COMPETITION
Bulletin

No. **98-1**

**SUBJECT: Underhood Cooling
on Summit X 670**

YEAR	MODEL	MODEL NUMBER	SERIAL NUMBER
1998	Summit X 670	1307/1310	All

LEFT SIDE SHOWN

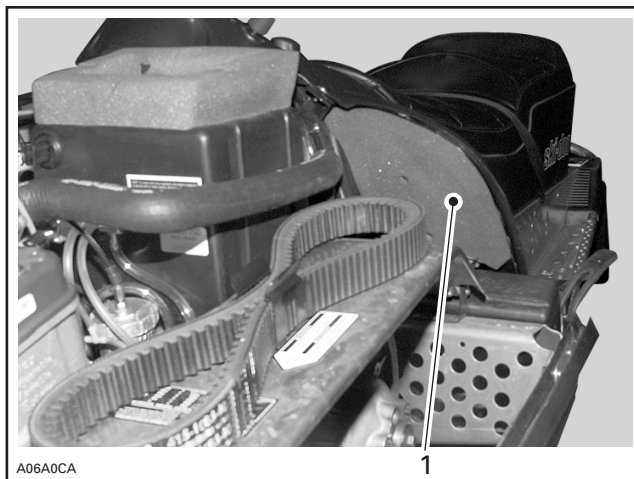
In order to lower the underhood temperature you may have to remove steel plate and foam behind the consoles, located on each side of the fuel tank.

From the engine side, unscrew plate and foam through holes seen in foam. Refer to following photo.

1. Remove plate and foam
